CITY OF EVERETT
548 Broadway Hazmat Removal
ADDENDUM NO. 1

Date Issued: May 11, 2026

Project: # EPS-26-21D – 548 Broadway Hazmat Removal

First Floor Plan - Section BB

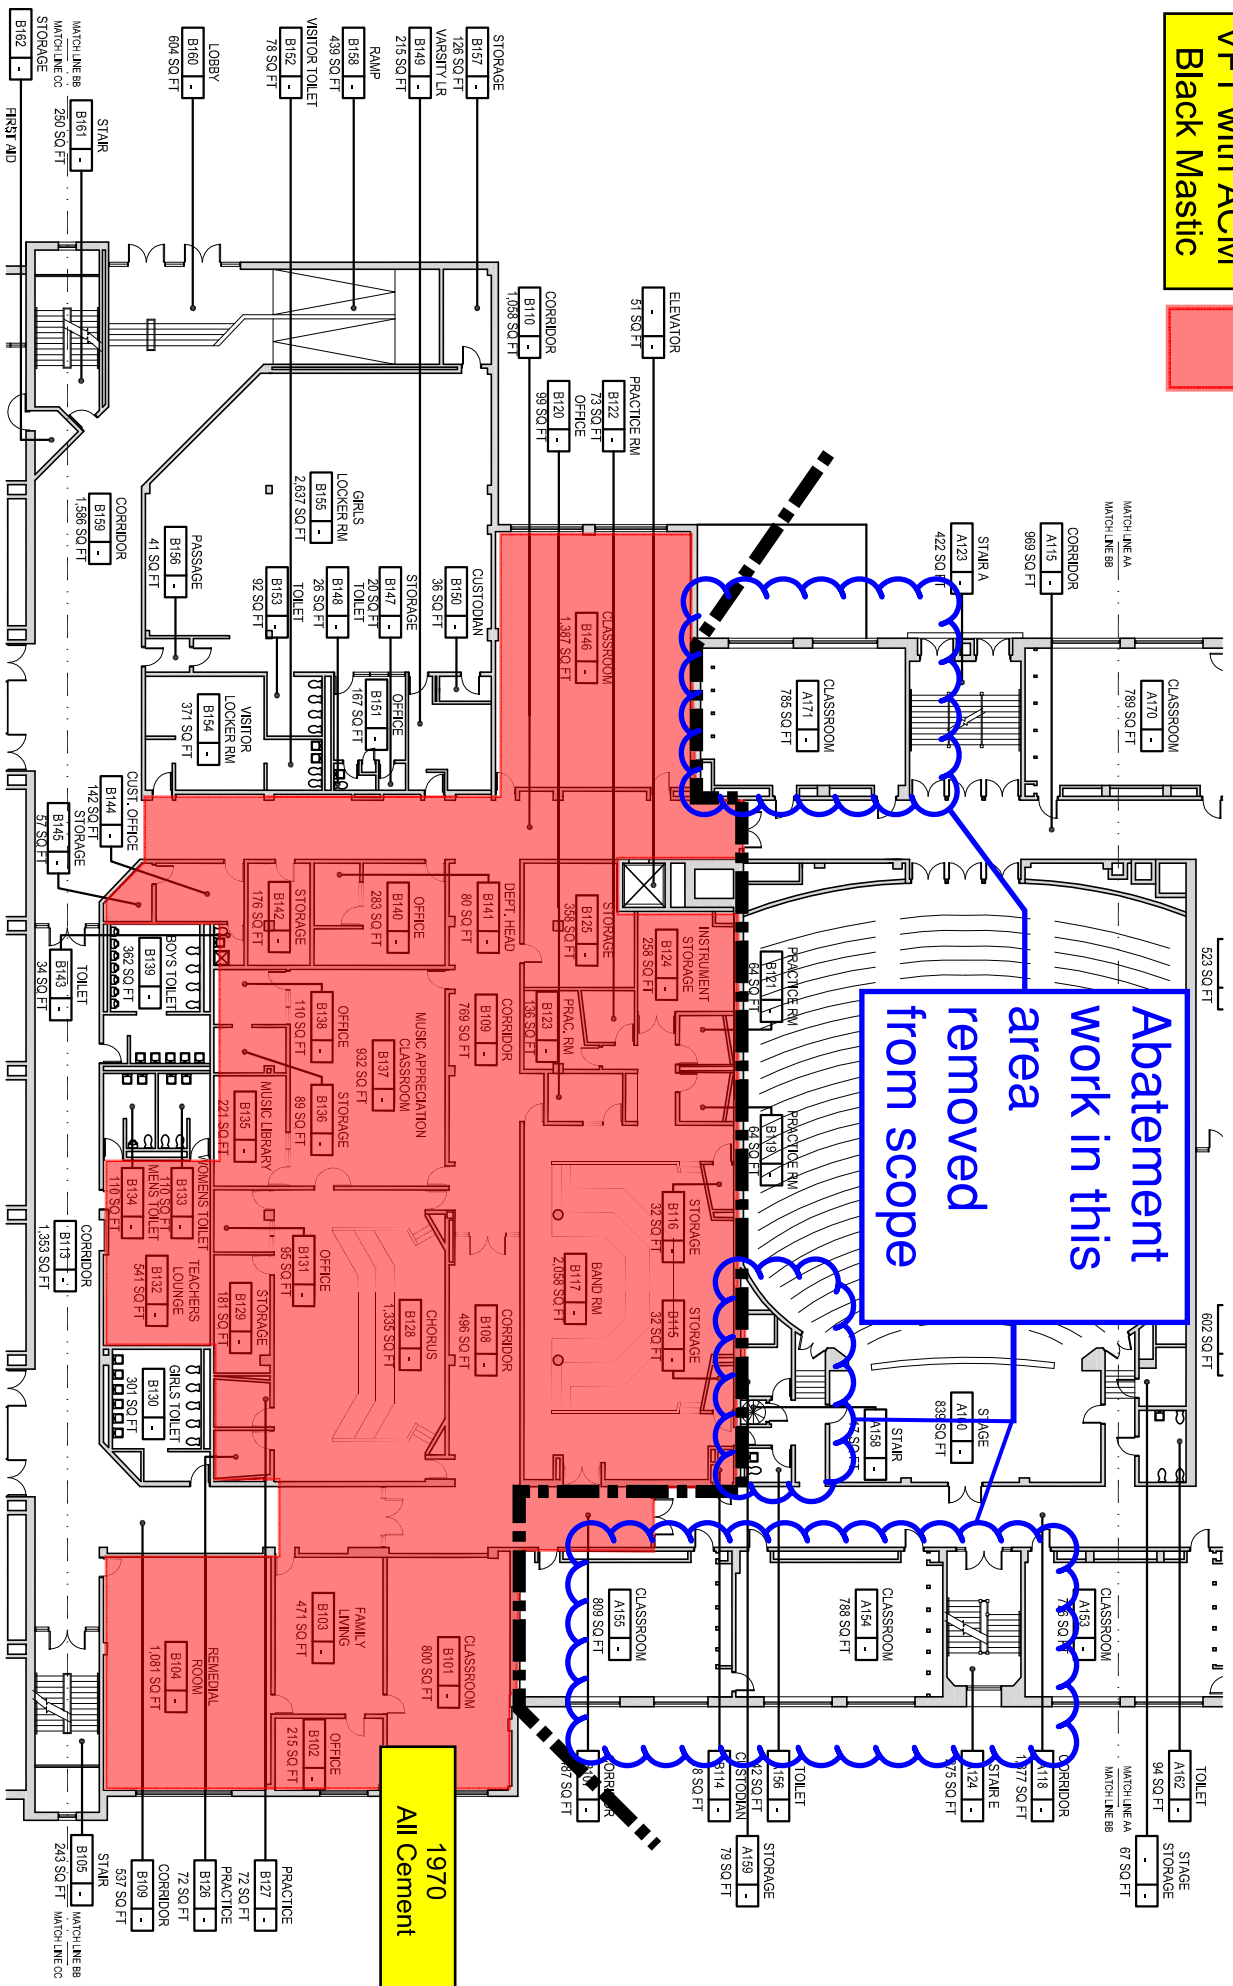
Answer: The most stringent wage rates are to be utilized.
- 5. Question:**The Phasing Plan calls for carpet tile to be installed on the first floor, and Section 09 63 13 gives us the specs on the carpet tile to be installed. I didn’t see on the drawings the area that is scheduled to receive the new carpet tile. Please clarify.

Answer: New carpet floor tiles are to be installed on the first floor where ACM flooring is scheduled to be removed. See First Floor Plan Section BB.
- 6. Question:** Are we to assume that all of the building contents are to be disposed of?

Second Floor Plan - Section CC

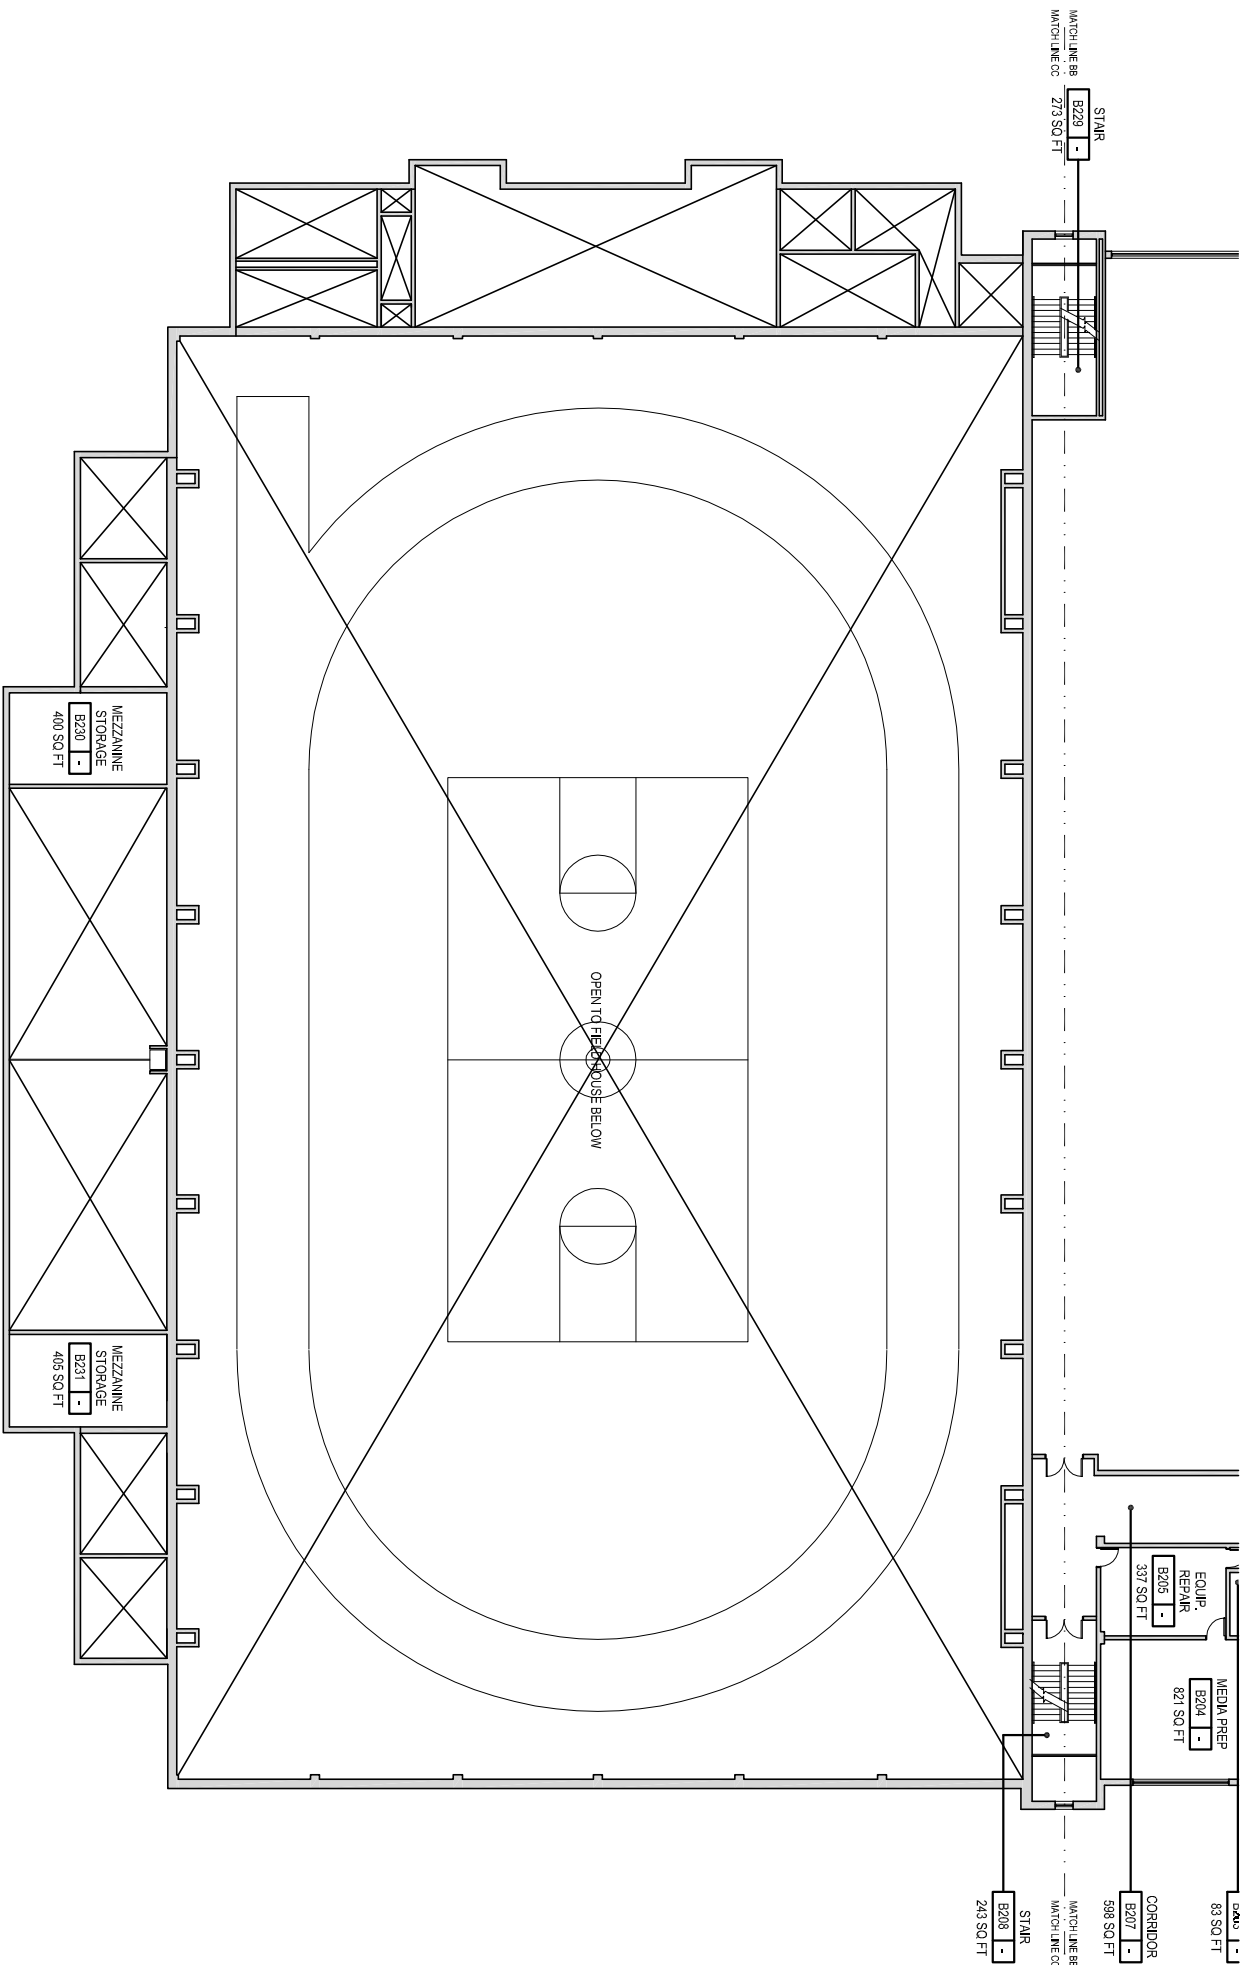
1. **Section 02 28 20, Part 3 (Execution), 3.01 (Scope of Work):**
Delete Item "D". Furniture will be removed prior to start of abatement. The Contractor, however, shall cover/remove after completion with 2 layers of polyethylene sheeting all remaining fixed furniture.
2. **Section 02 28 20, Part 3 (Execution), 3.01 (Scope of Work):**
Add the following: The Contractor shall closely coordinate work (including several containment set-ups) with City officials, as part of the building (ground floor) are being continuously operated by the City during this abatement project.
3. **Section 02 28 20, Part 3 (Execution), 3.01 (Scope of Work):**
Delete Item 14. (Stage curtain scope.) from F. Specific Notes.
4. **Section 02 28 20, Part 3 (Execution), 3.01 (Scope of Work):**
Delete from Second floor Various items scope the Stage light Wiring
